STAFF RECOMMENDATION

NCPC File No. 6704

**WHITE OAK FEDERAL RESEARCH CENTER
FOOD AND DRUG ADMINISTRATION
SOUTHWEST PARKING GARAGE
Montgomery County, Maryland**

Submitted by the General Services Administration

REVISED PHASING PLAN III B

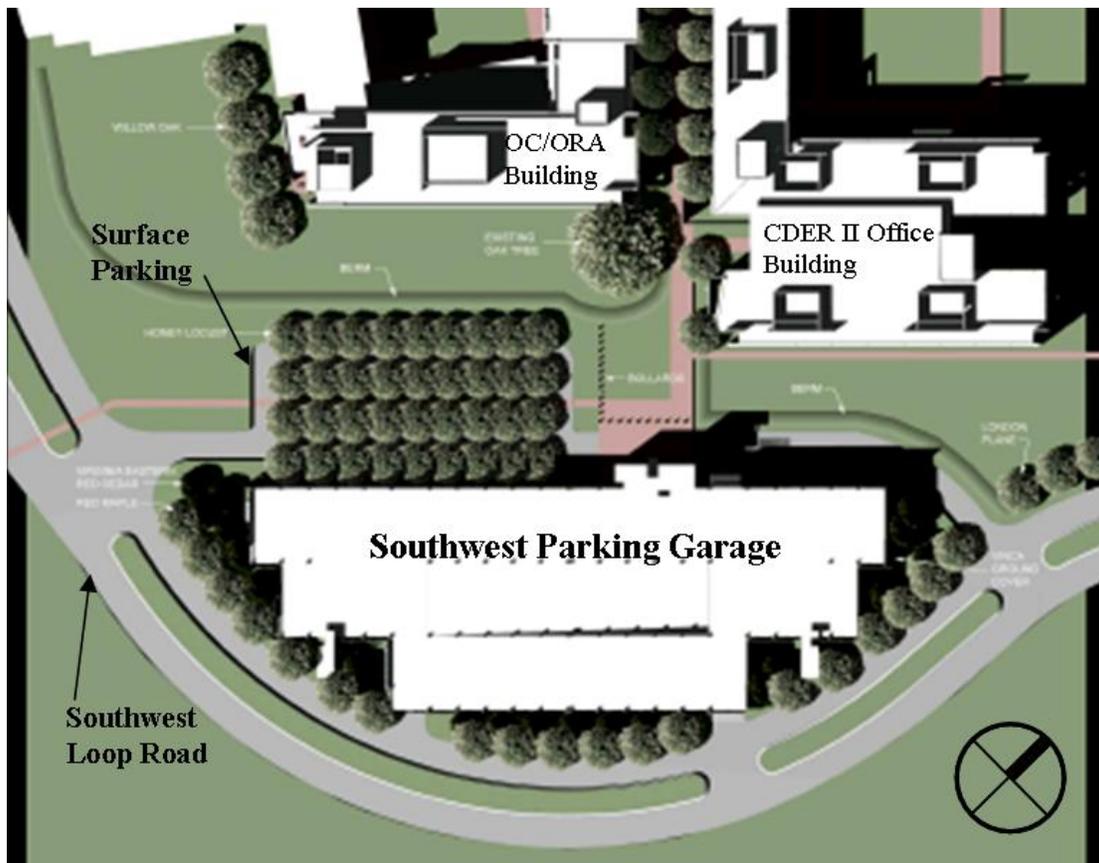
Although Staff commends the applicant for submitting both the illustrative plan and the TMP portions of the revised Phasing Plan IIIB, the revision to the master plan is not yet complete because the remaining phases will be effected but have not been revised and resubmitted. Although the applicant states that this modification will be fully reconciled with the master plan at the conclusion of the next phase (Phase IV), this has not been demonstrated. Because 359 of the 552 spaces that would have been added in Phase V are being moved up two phases to Phase IIIB, it is unclear when the modification would be reconciled without analyzing Phases IV & V to demonstrate when the reconciliation of parking ratio will occur. In fact, the applicant's calculation of parking results in 1400 spaces rather than 1352. This is because Phase V designates 48 of the spaces in the Southwest Garage as visitor spaces, and that number increases to 78 in Phase VI. In addition, the applicant points out that 140 spaces will be relocated from a proposed underground structure to another future above ground structure, but has not specified which structure or which phase. The underground portion of the garage still appears in later phases of the master plan, and therefore needs to be revised for accuracy and consistency. Based on analysis, staff recommends revision and resubmittal of Phasing Plan IV prior to submitting any future projects.

PROJECT SITE PLAN SHOWN LANDSCAPED

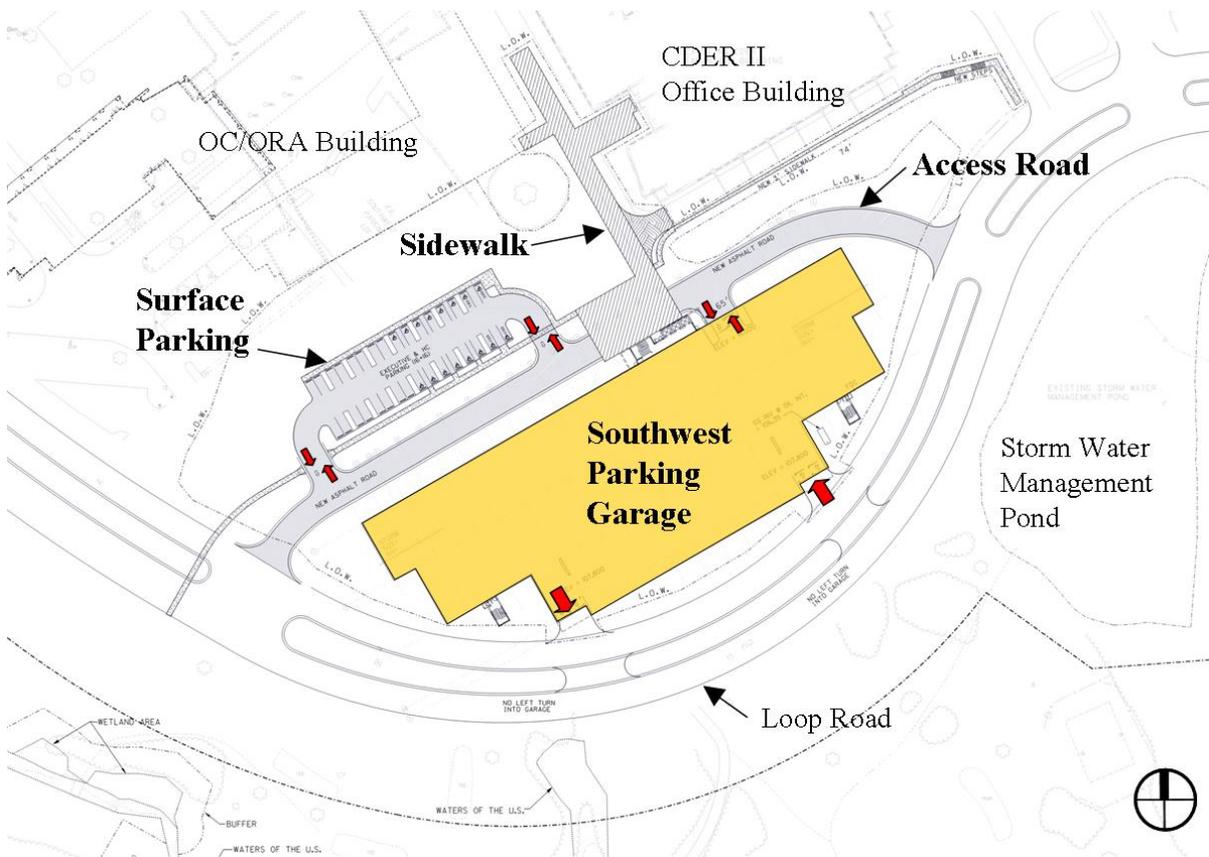
The building's rectangular footprint is a deviation from the curvilinear plan shown in the master plan following the curve of the Loop Road. The applicant has explained this change in geometry in the narrative, stating that "All other garages on site are rectangular in plan.", and that the shape of the garage has changed so that "the language of all garages on the campus are related in much the same way as the buildings relate to each other." While the earlier 2002 master plan showed all three planned garages (North, Southwest, and Southeast) as curved shapes defined by the perimeter loop road surrounding them, it is true that as vision has evolved towards reality, footprints for the other 2 garages have become more rectangular in the 2006 master plan. In it, the North Garage has been separated into two distinct but connected buildings and phases. The first phase, still called North Garage, appears as a rectangle connected to a later phased triangular Northeast Parking Garage which retains only an outer curved edge to conform to the road.

In discussions, the applicant has acknowledged that the decision to straighten the curved form was also based at least partly on construction economics and the cost benefit to taxpayers after earlier iterations of the Southwest Garage designed with the curve did not conform to budget restrictions. However, stepping the three bays at different lengths in plan along the curve creates tension between the forms of the building and the curved loop road. Staff believes that

landscape planting between the building and the road will help re-establish the curved form. While the proposed design shows the garage in the same location as in the master plan, it includes a surface parking lot in an area where the master plan indicated underground parking. In this aspect, the applicant acknowledged an even greater basis in construction economics for eliminating the underground structure. The narrative states “GSA has determined that underground parking is not feasible within the budget constraint of the project”. The 140 underground parking spaces will be relocated to one of the planned above ground structures that remain to be constructed in future phases.” Although the Comprehensive Plan for the National Capital’s Transportation Element states a preference for below ground rather than above ground parking structures, staff does not believe that replacing underground structured parking with above ground structured parking will be as detrimental to the urban design in this location as it would be in a more dense urban area.

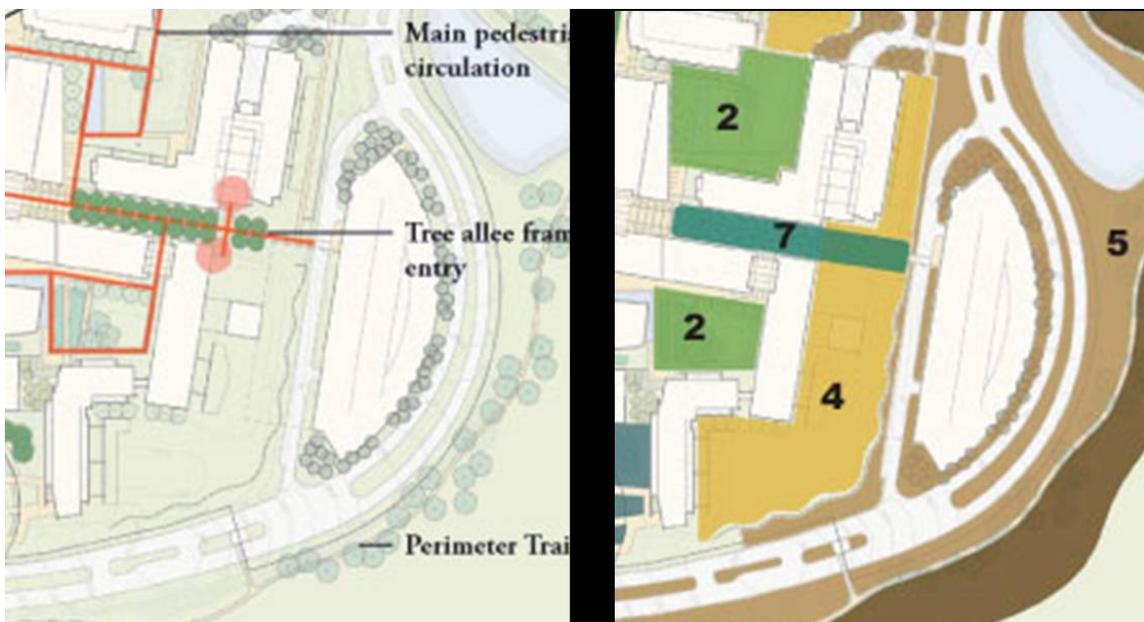
The landscape is a significant feature of this project’s integration into the campus plan because the building perimeter has been straightened from a curve to a series of rectangular shapes. Landscaping is therefore seen as essential for this project because it will define the campus edge and perimeter Loop Road, and help to reestablish the curve, which has been removed from the building configuration, by filling in the space between the angles of the building and the curve of the road. It is staff’s view that the landscape plan submitted accomplishes the goal of reestablishing the curve along the Loop Road. It also frames the entries of the two office buildings that it supports in a way that is consistent with the landscape component of the master plan. This aspect of the design, shown in images from the landscape plan including Landscape Zones and Pedestrian Circulation, shows an entry zone where allees of trees frame entries to buildings. In addition, the bosque of honey locusts to be planted northwest of the garage canopy will partially soften and shade the surface parking lot and break down the visual mass of the length of the garage.

Staff commends the FDA Project Executive for making the commitment to obtain funding for and to plant the trees on all sides of the building as soon as the building is complete. Staff recommends approval of the landscape design in this submittal and planting at completion of garage construction.
